[I] Redline Revision Dated October 14, 2008

MD 24 (Vietnam Veterans Highway) at W. MacPhail Road

TRAFFIC SIGNAL PLAN

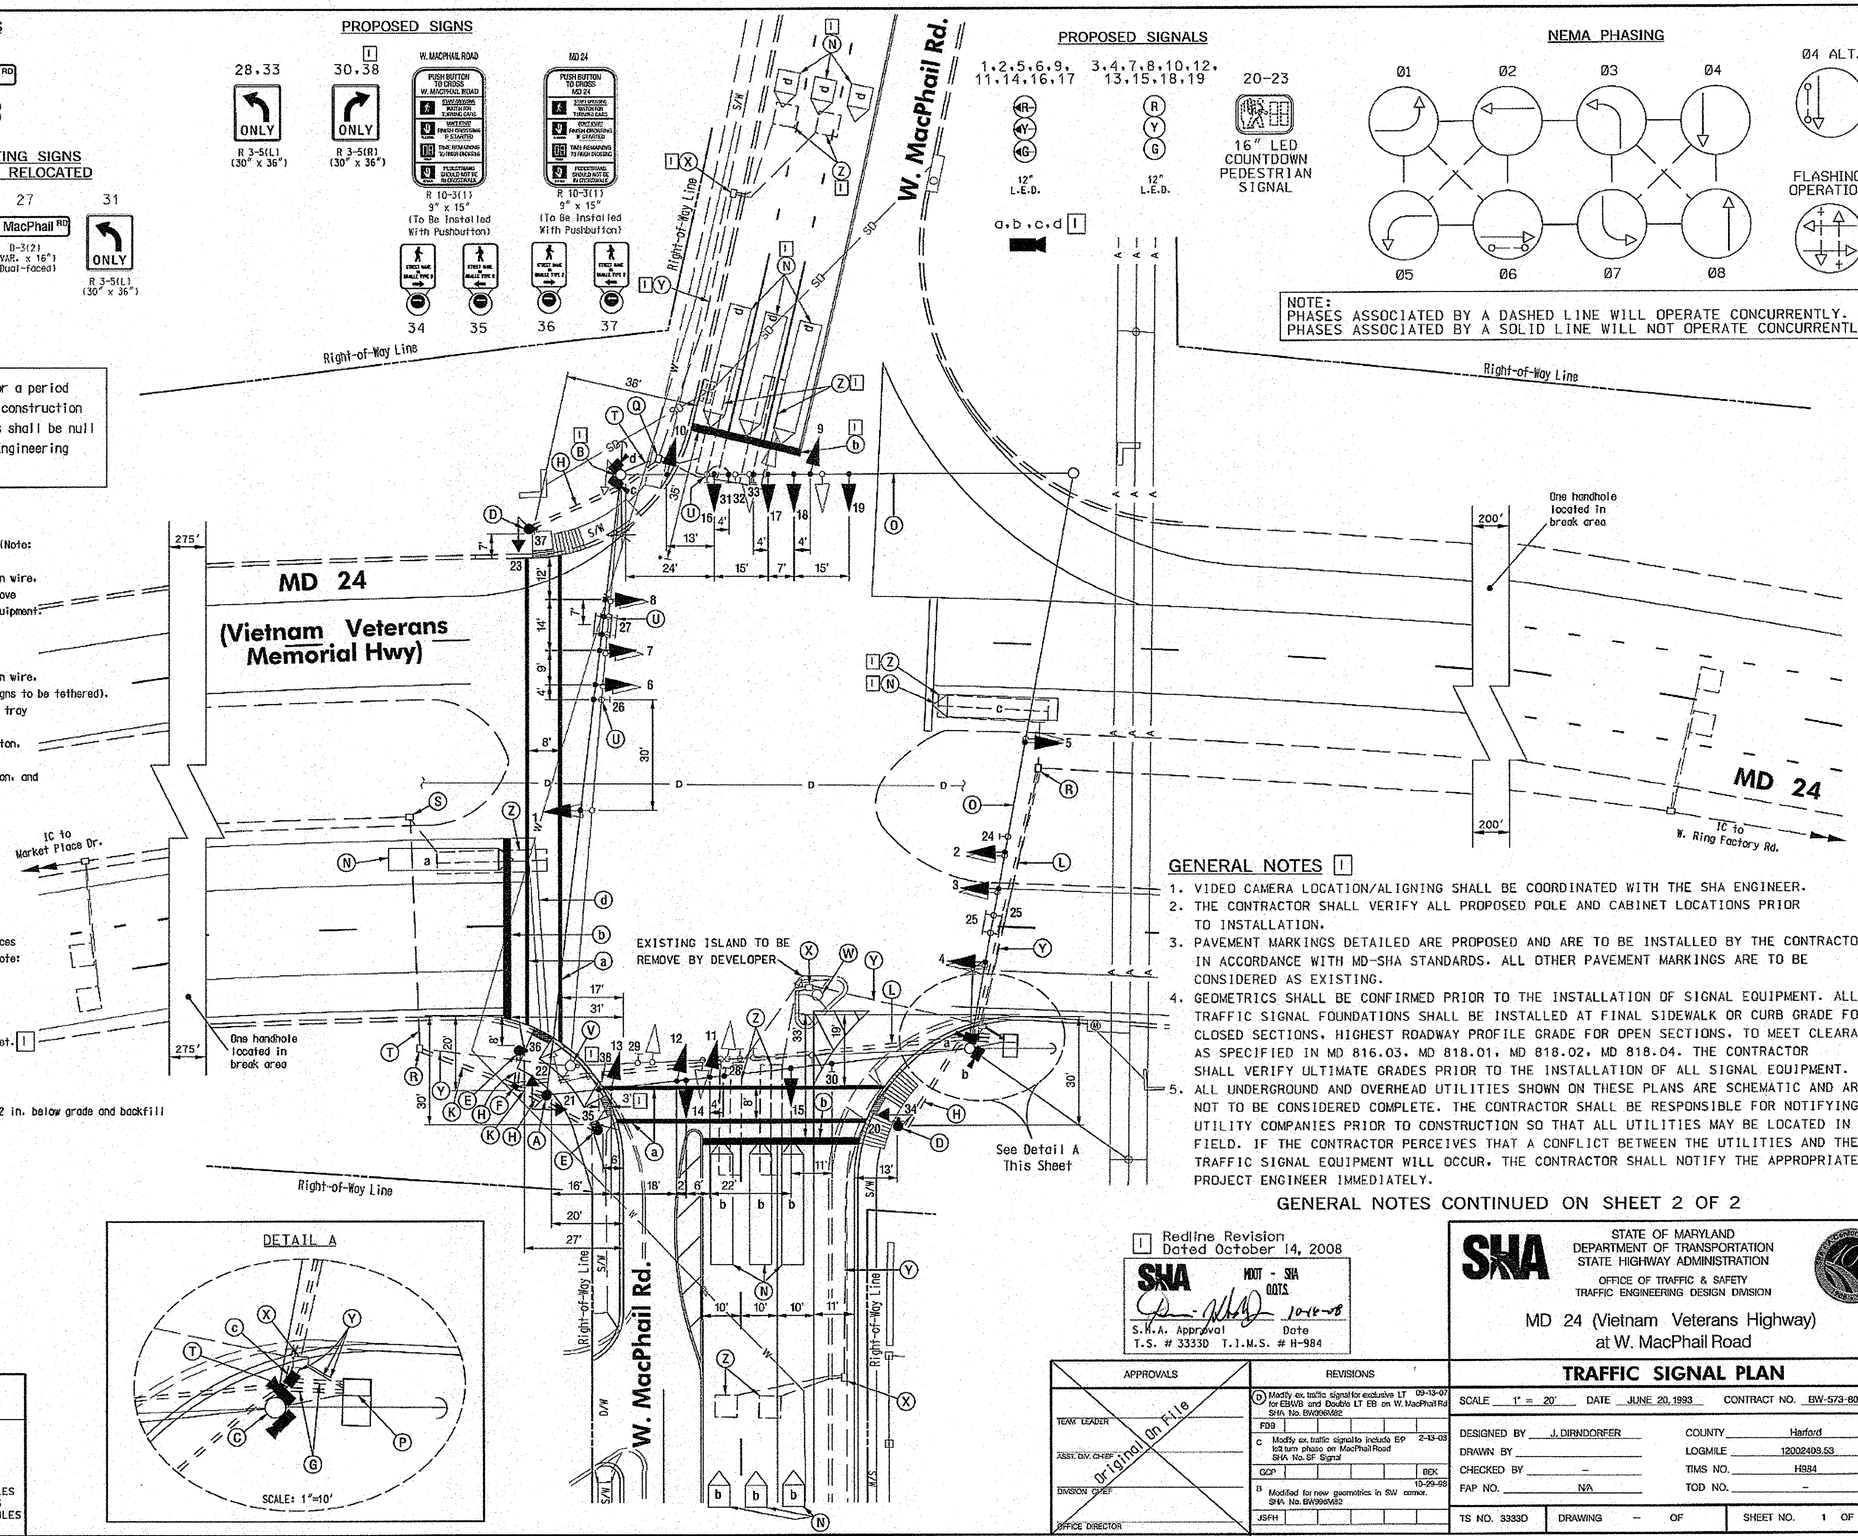
K. Install 3 in. polyvinyl chloride [Schedule 80] electrical conduit - trenched.
L. Install 4 in. polyvinyl chloride [Schedule 80] electrical conduit - bored.
~~M. Install HAPPIPM pavement marking symbol - white (LEFT Arrow)~~ [I]

N. Video detection zone.
O. Use existing span wire remove and replace signal heads and signs as shown.
P. Use existing cabinet/controller, install APS central control unit and SHA forces shall retrofit controller equipment to operate video detection equipment. (Note: install two 4 in. PVC conduit bends in existing base).
~~Q. Use existing handhole, splice new 2-conductor aluminum shielded cables to existing loop wire and rerun new cable to existing cabinet.~~ [I]

d. Remove existing pavement marking by grinding.
~~e. Install 10 in. wide solid yellow pavement marking - for gore area.~~
~~f. Install 5 in. wide white solid pavement marking for lane line.~~
~~g. Install 5 in. wide white broken pavement marking (10 ft. segment - 30 ft. gap) for lane line.~~ [I]
~~h. Install 5 in. wide double yellow pavement marking - for center line.~~
~~j. Tie to existing markings.~~
